## Level 1 Floorplan

## Modifications

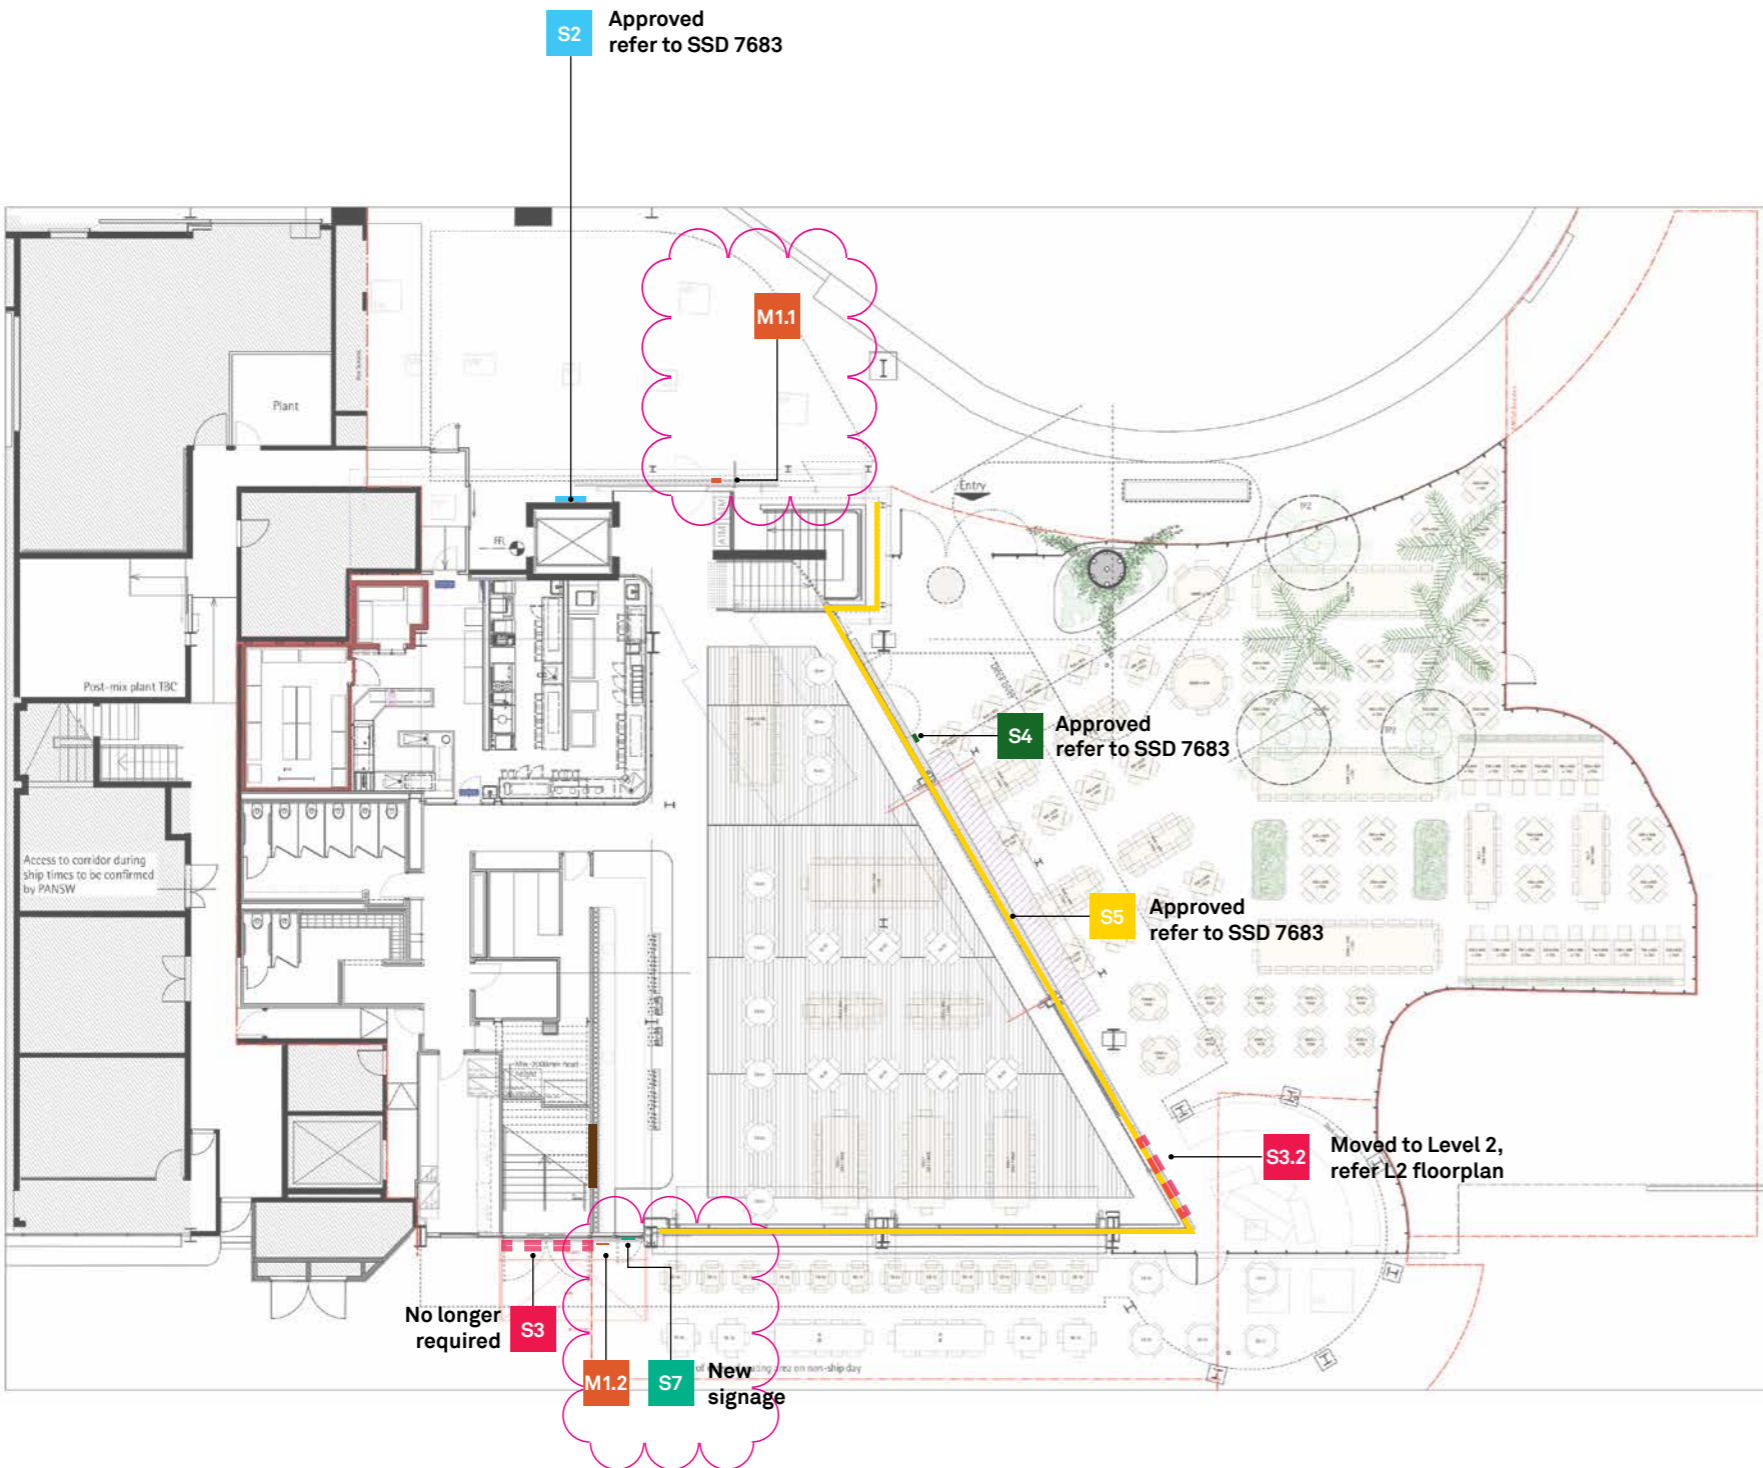
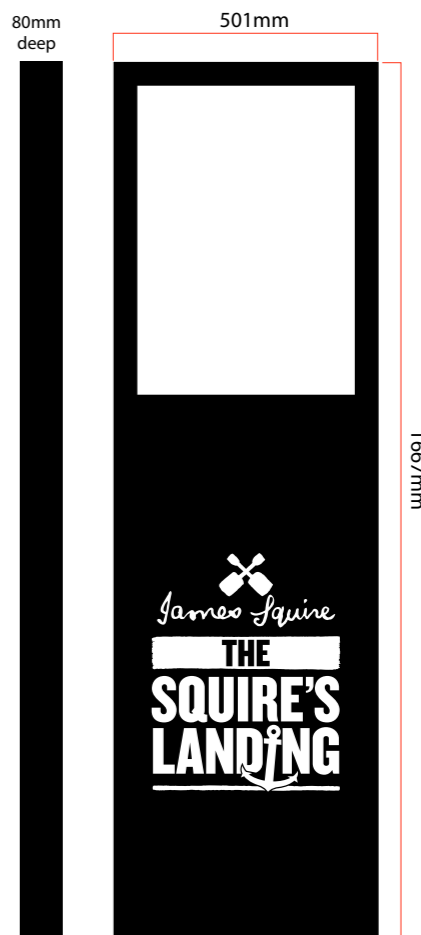
**S7 The Squire's Landing logo window vinyl**  
Non-illuminated – ground floor external door.  
New vinyl signage – as this door is being used by customers as an entry point

**S3.2 James Squire Signature + Cross Shovels identification**  
moved to Level 2, refer L2 floorplan

**M1 Menu Stand**  
Freestanding menu stand with illuminated logo and menu

Two new menu stands see construction below

Level 2 Floorplan

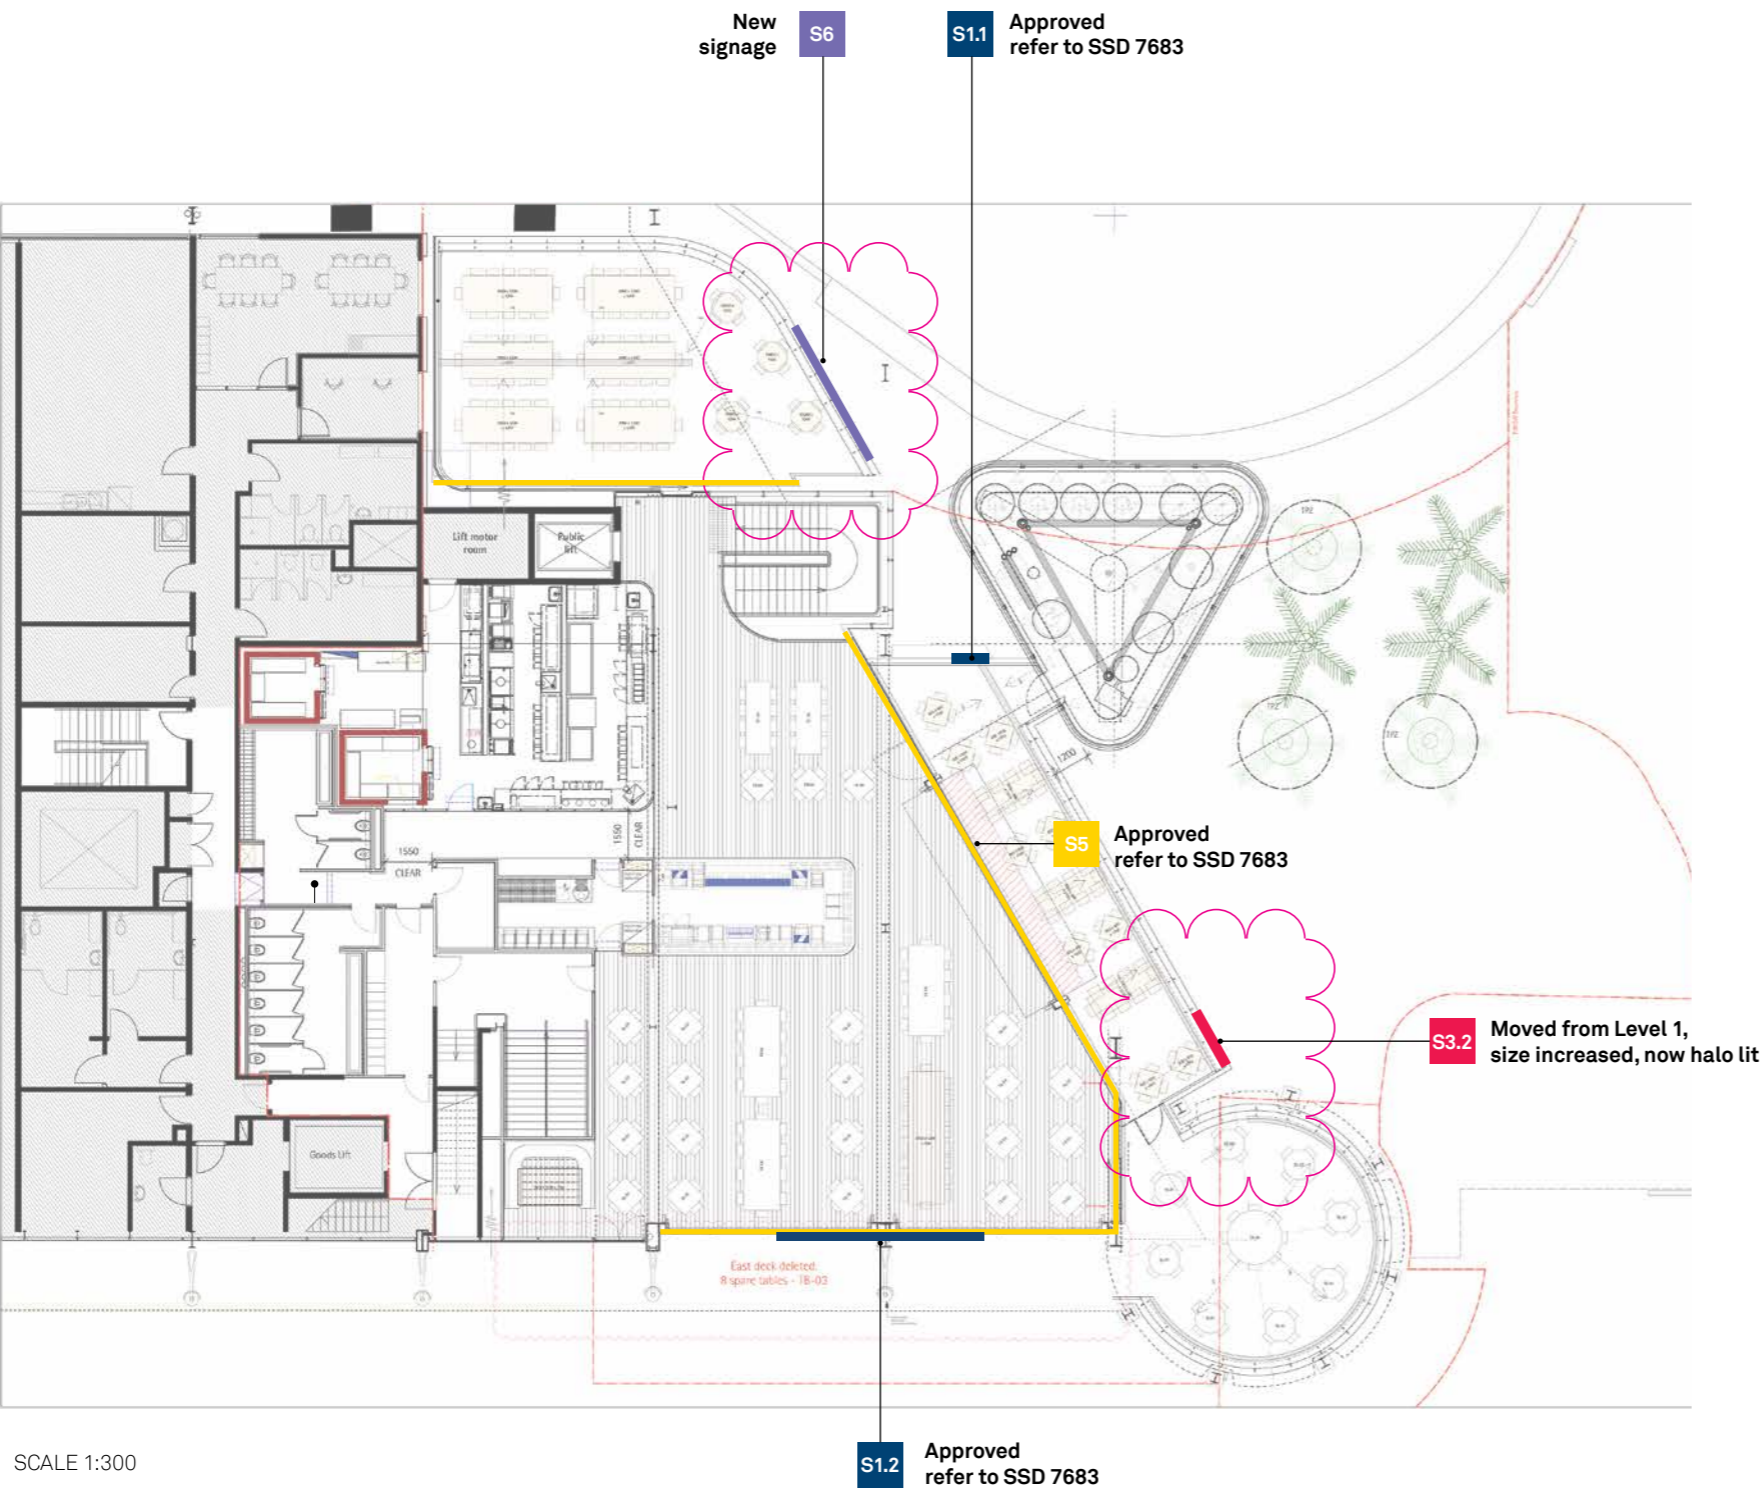
- S3.2 James Squire Signature + Cross Shovels identification**  
**S3.2:** relocation from ground floor low level building spandrel to Level 2 awning beam. Size increases from 1285 x 220mm to 2440x380mm. Sign now halo lit.
- S6 The Squire's Landing identification**  
New sign Level 2 balcony. Sign is illuminated.

01 East Elevation  
Scale 1:200

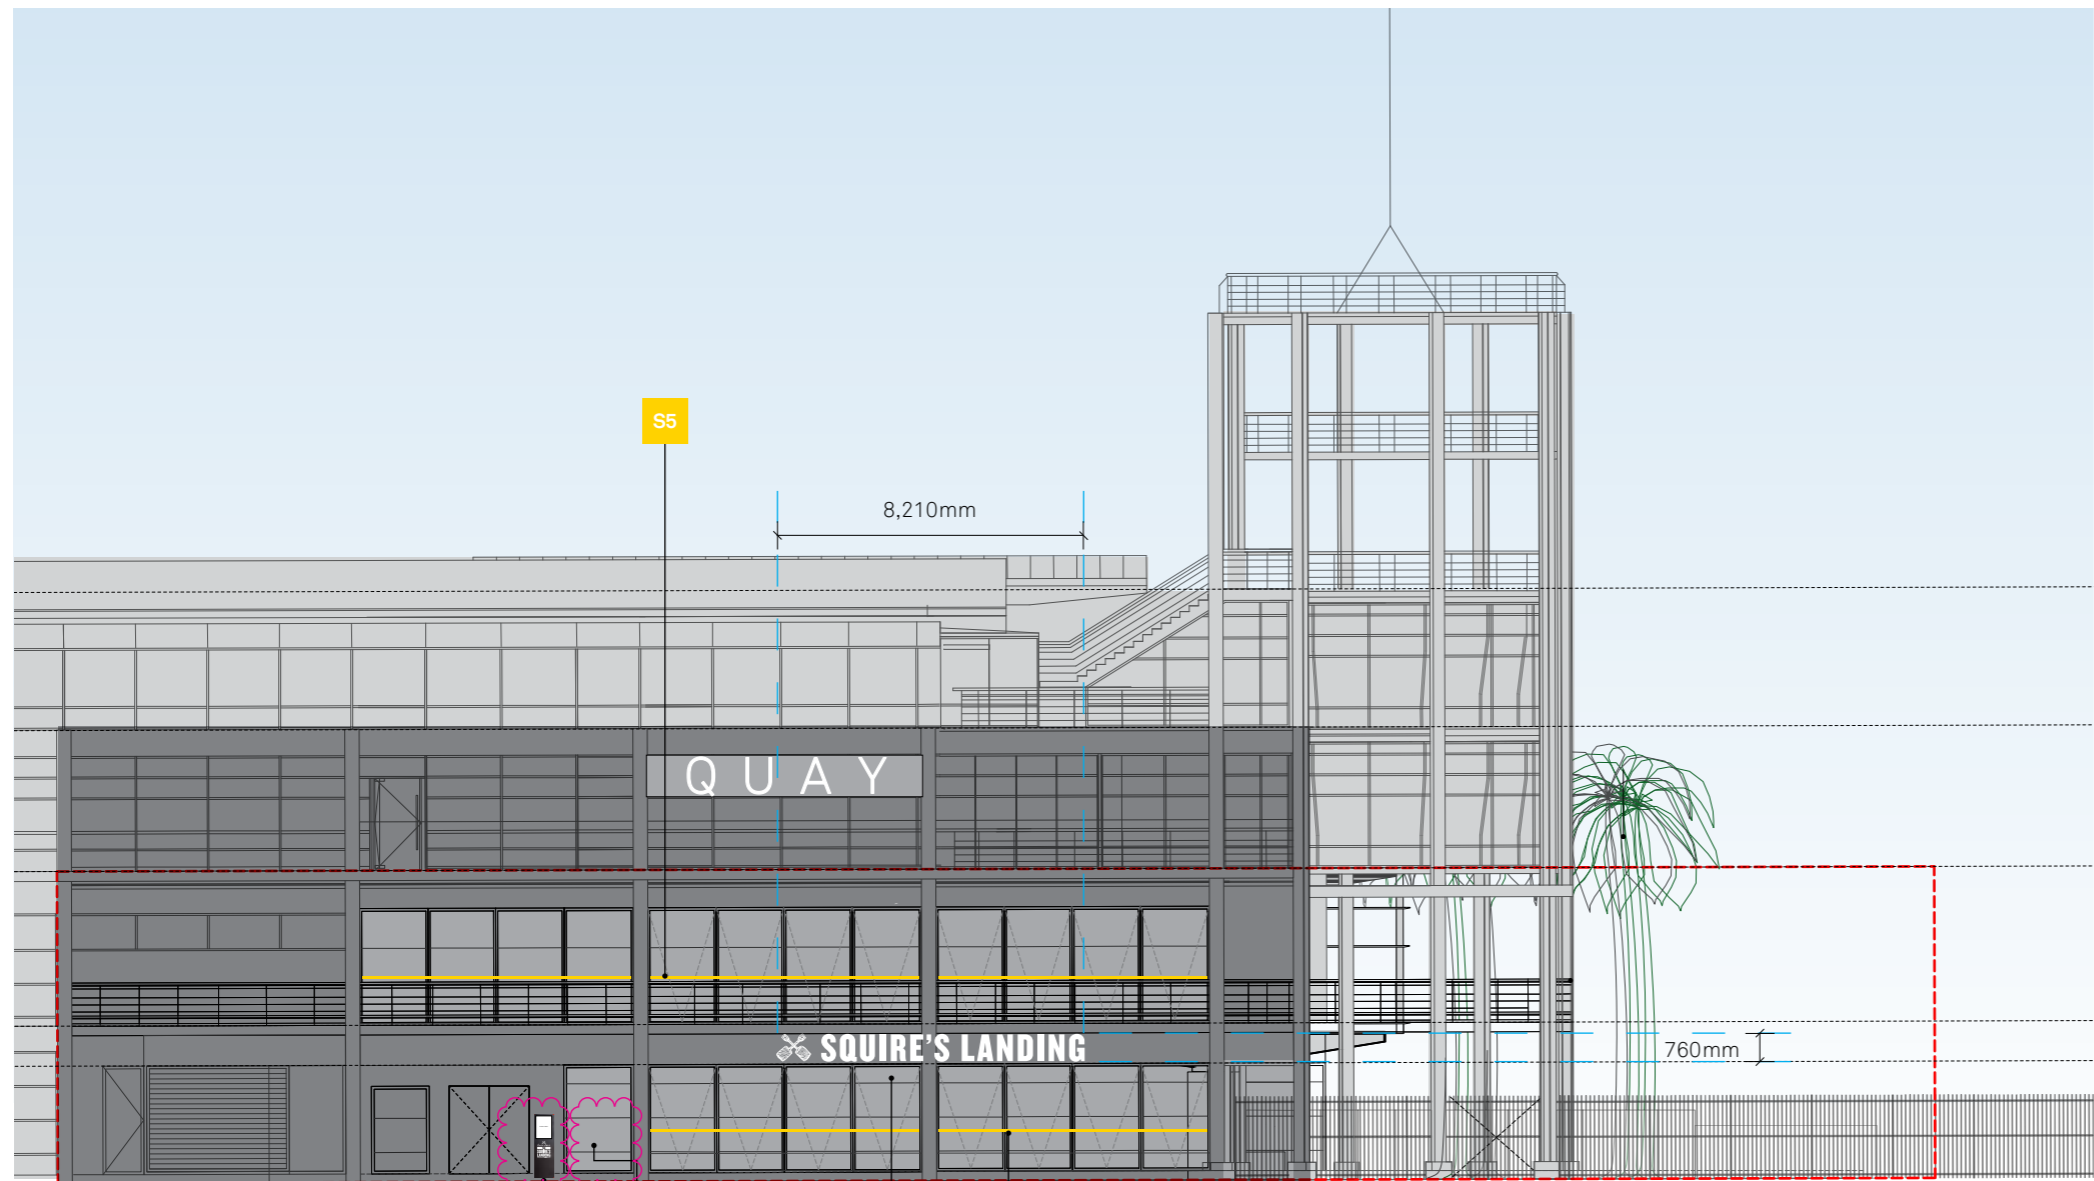
- S7** **The Squire's Landing logo window vinyl**  
Non-illuminated – ground floor external door.  
New vinyl signage – as this door is being used by customers  
as an entry point
-  **M1** **Menu Stand**  
Freestanding menu stand with illuminated logo and menu

Modifications – New Signage

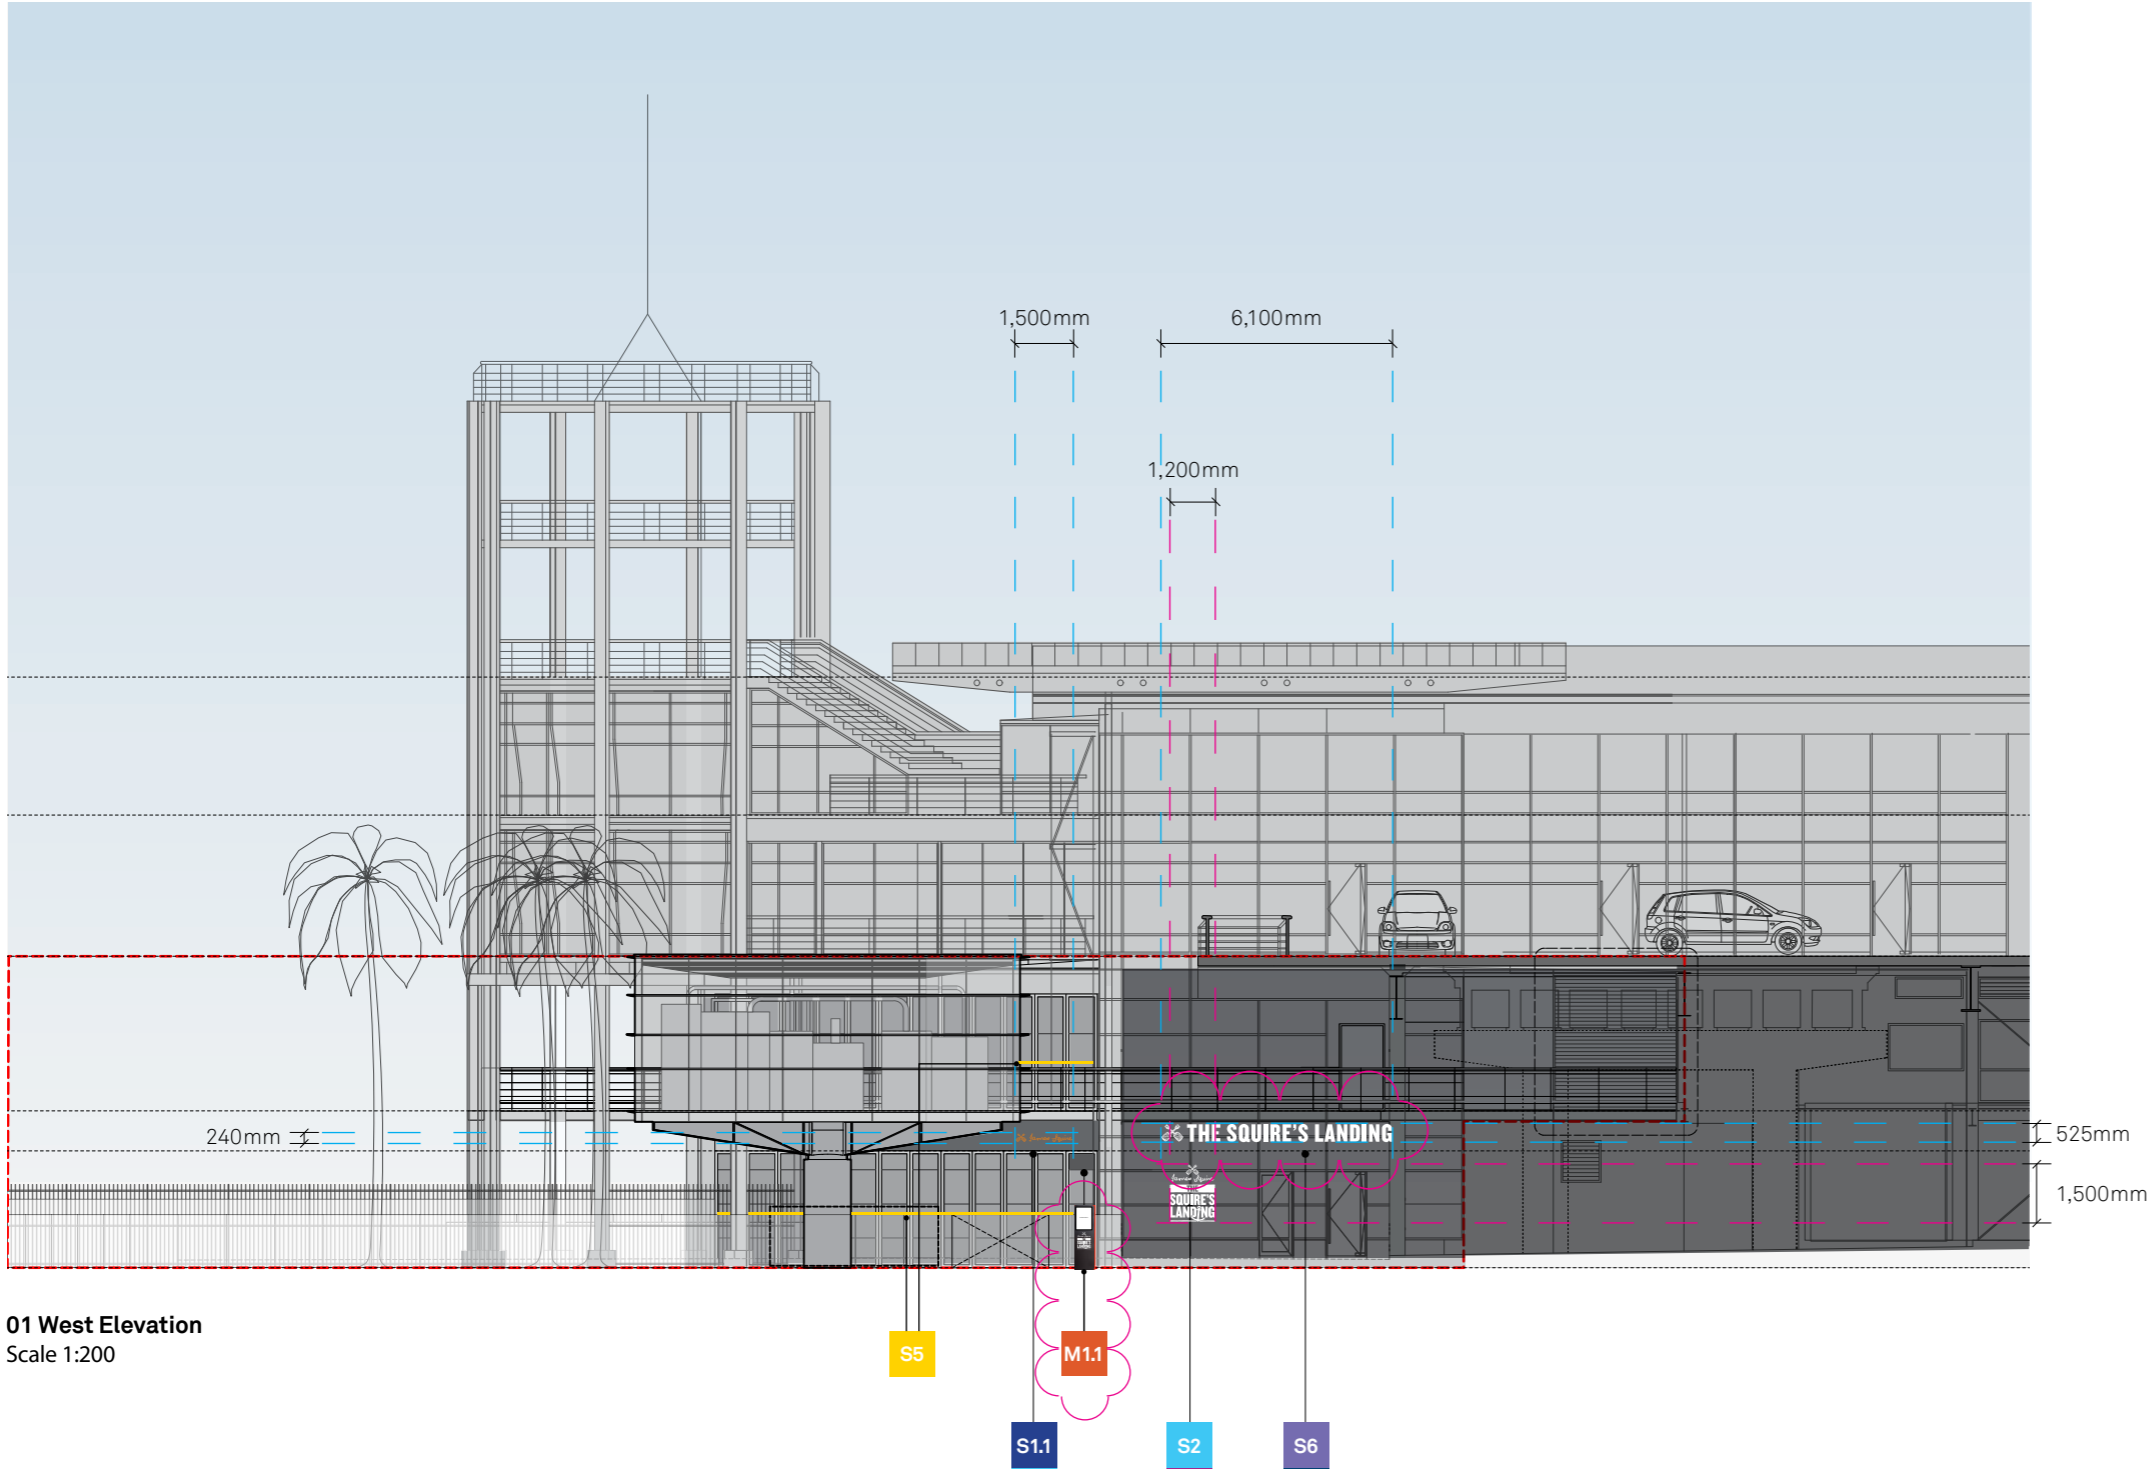
**Menu Stand**  
Freestanding menu stand with illuminated logo and menu

**The Squire's Landing identification**  
New sign Level 2 balcony. Sign is illuminated.
